Summary	Wiring of the Thermal Overload				
Products Affected	Powerhouse Doors with GFA Motor Replacements				
Key Word Tags	PH, Thermal, Wiring				
Tools/Equipment (If Required)	Terminal Screw Driver				
Parts/Materials (If Required)					
Related Media					
Author	M. Burzlaff	Issue Date	5/4/2016	Status	Active

A change has been made to the GFA motor requiring 2 additional wires for the thermal overload protection in the motor.

SYSTEM 4 CONTROLLER CONNECTIONS:
MOTOR THERMO PROTECTION WIRING
DETAILS.

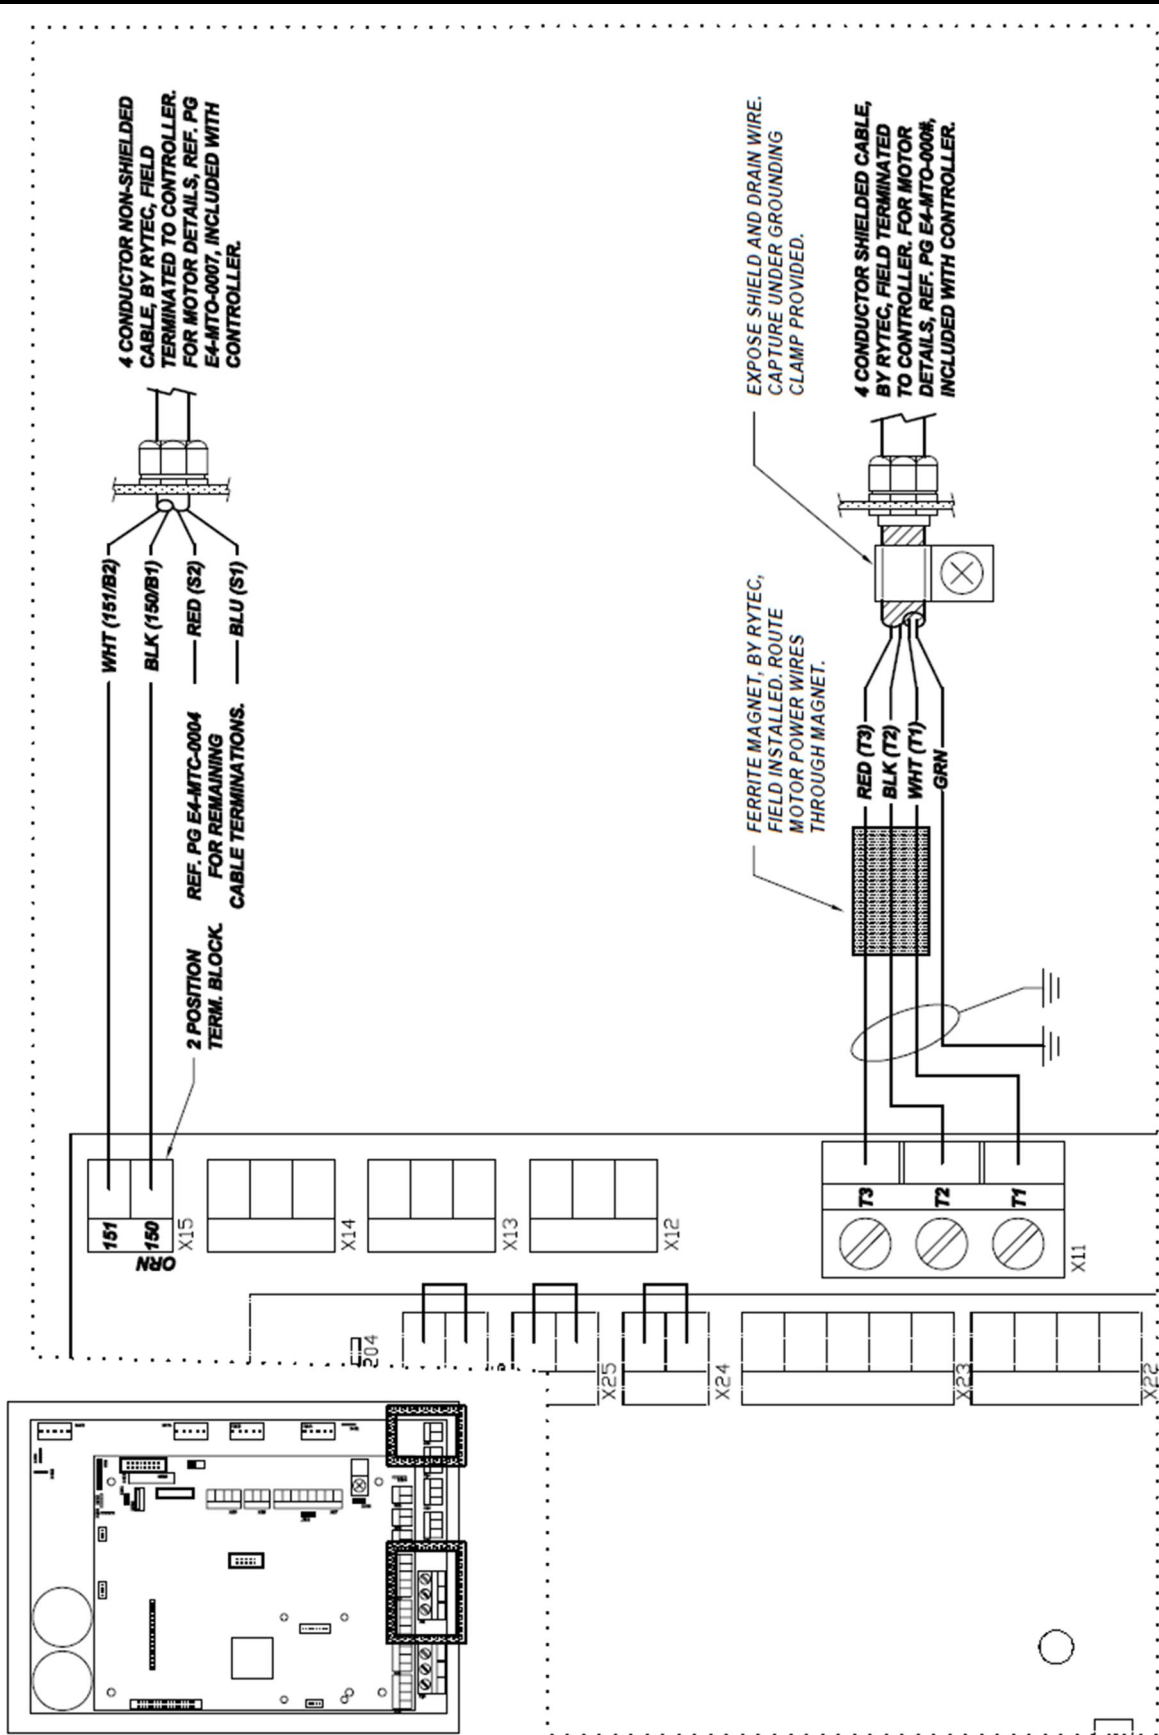
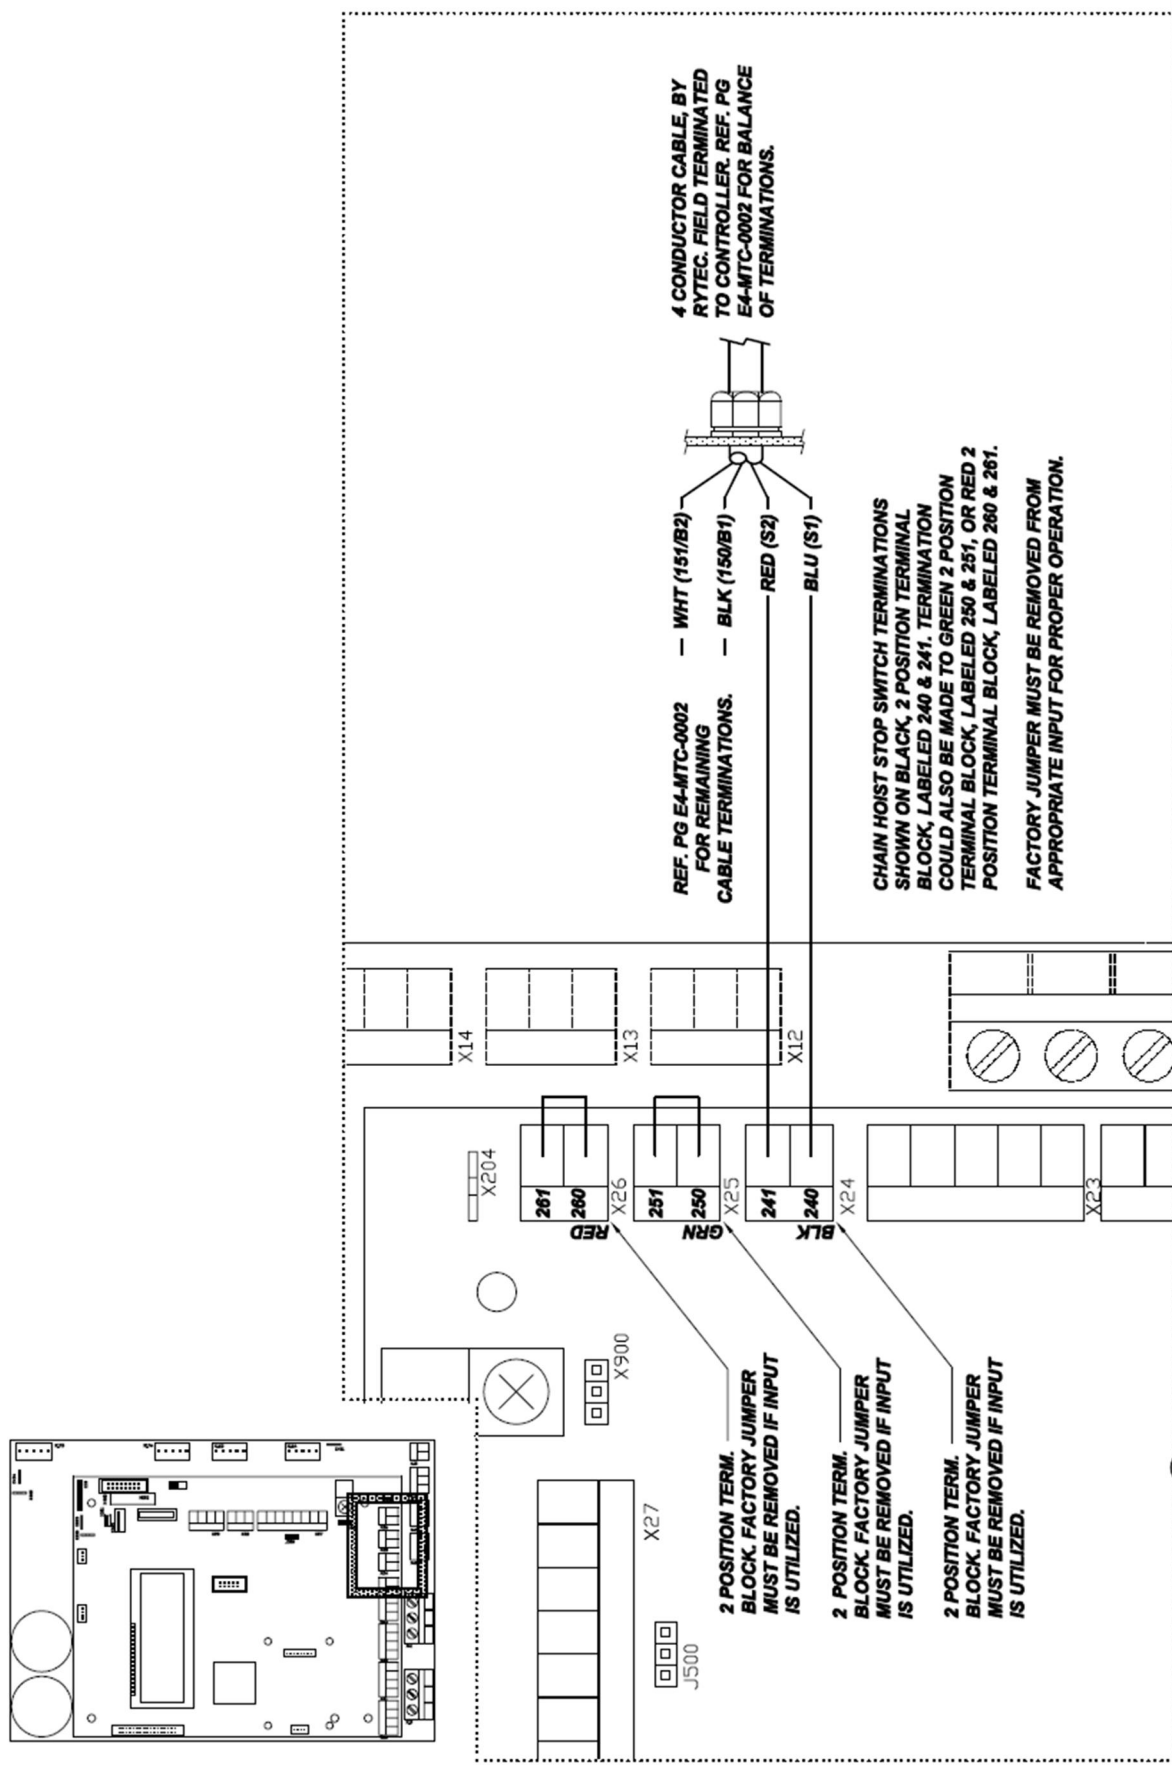
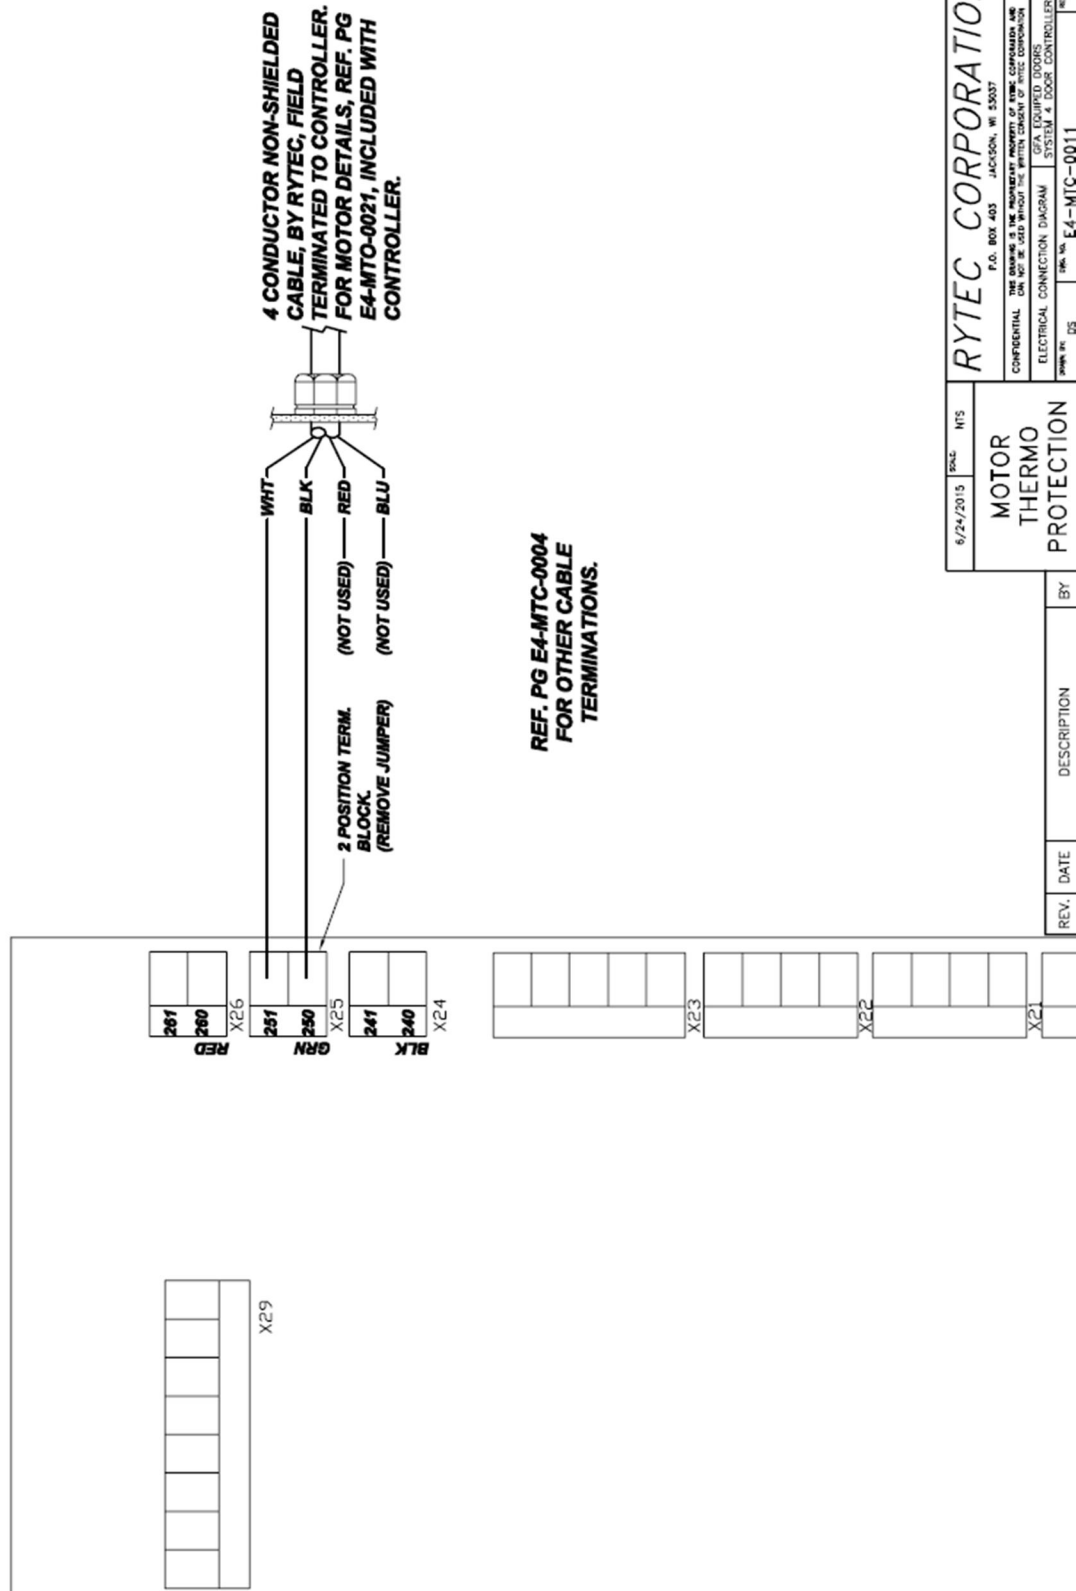
The following schematics are to be used as a reference for the wiring of the new thermal protection.

**MOTOR JUNCTION BOX**

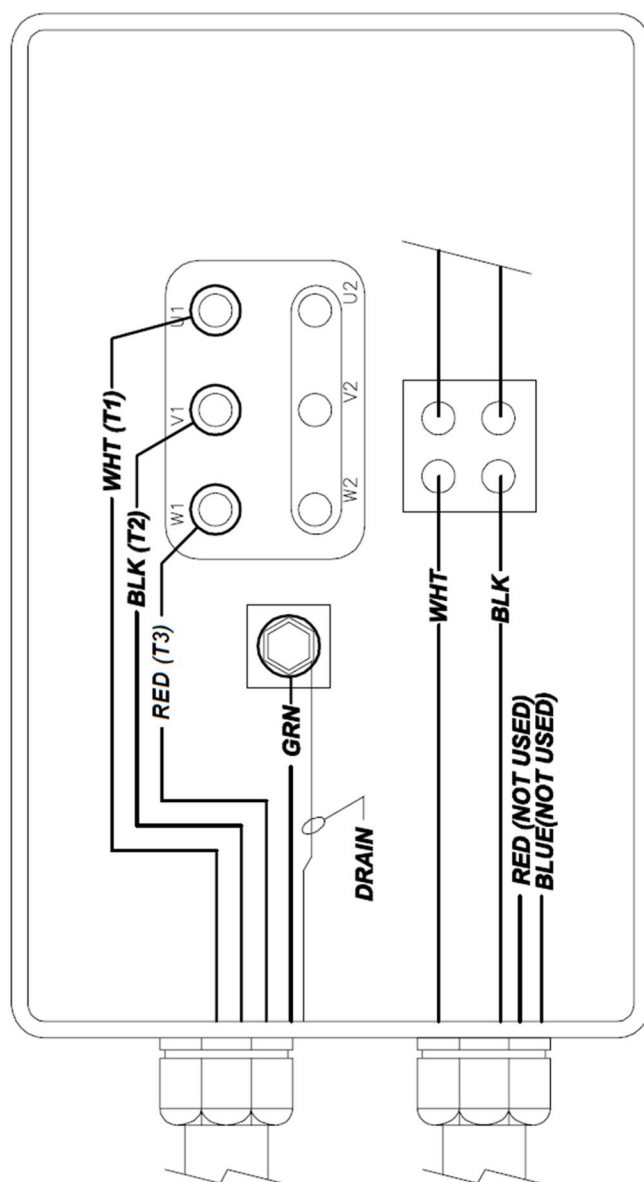
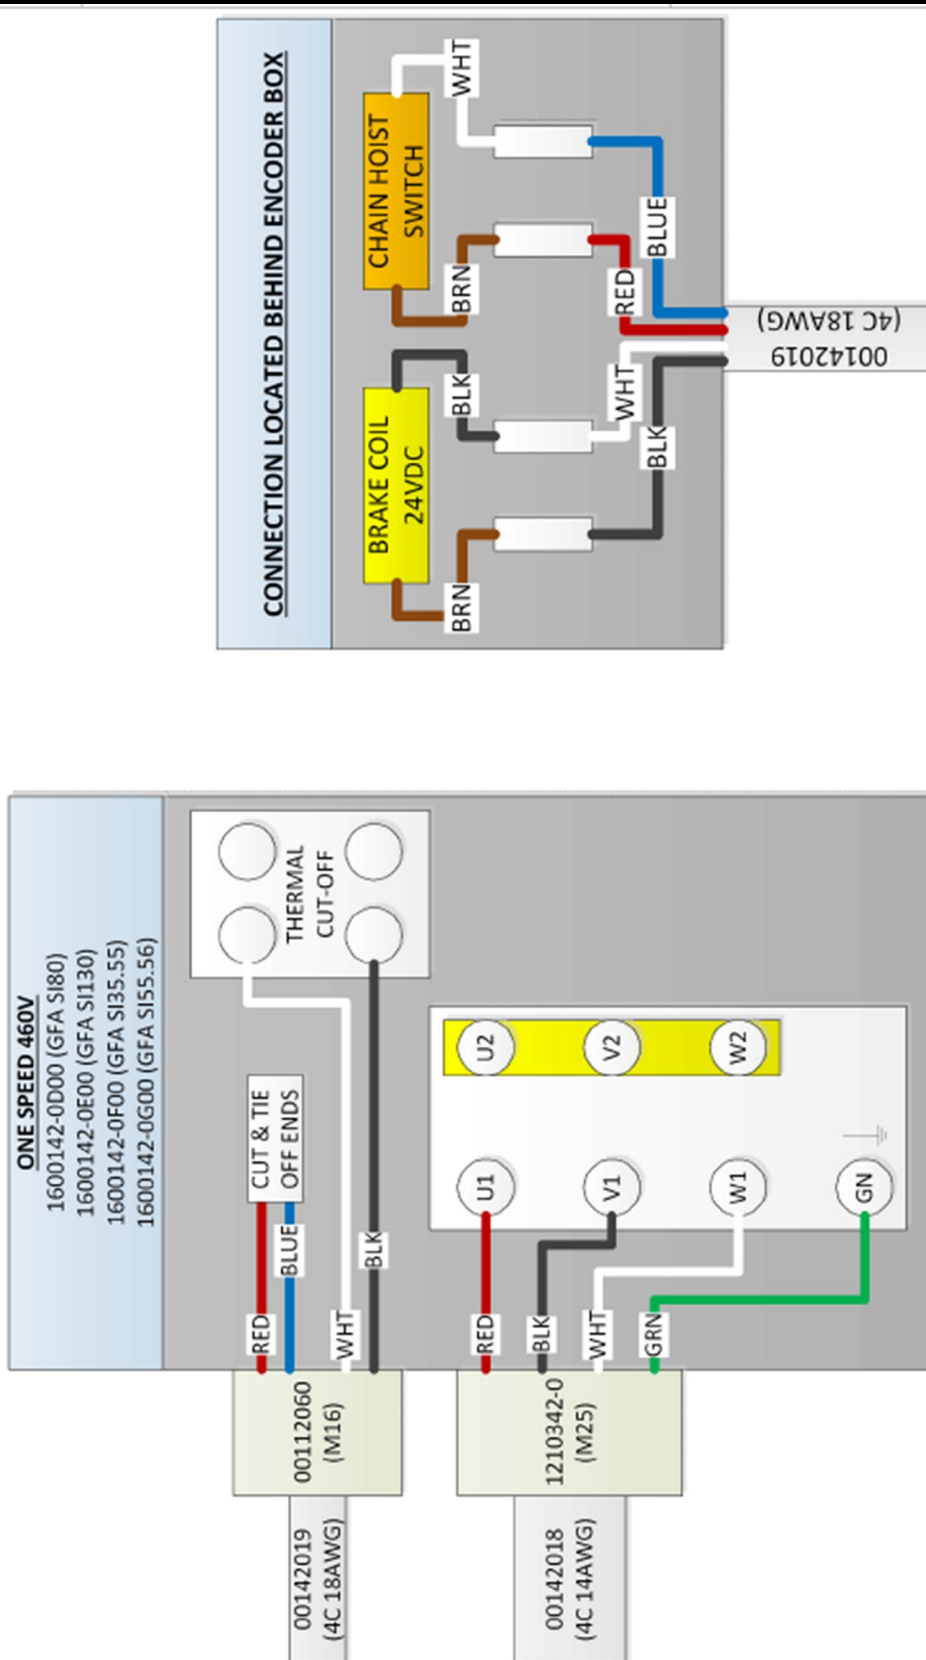
**MOTOR POWER CABLE, 4
CONDUCTOR, 14 GAUGE SHIELDED
CABLE, TO CONTROL BOX. REF. PG
E4-MTC-000# FOR CONTROL
TERMINATIONS.**

**MOTOR THERMO PROTECTION
SWITCH CABLE, 4 CONDUCTOR, 18
GAUGE, NON-SHIELDED. SEE
DRAWING E4-MTC-0011 FOR
CONTROL BOX CONNECTIONS.**
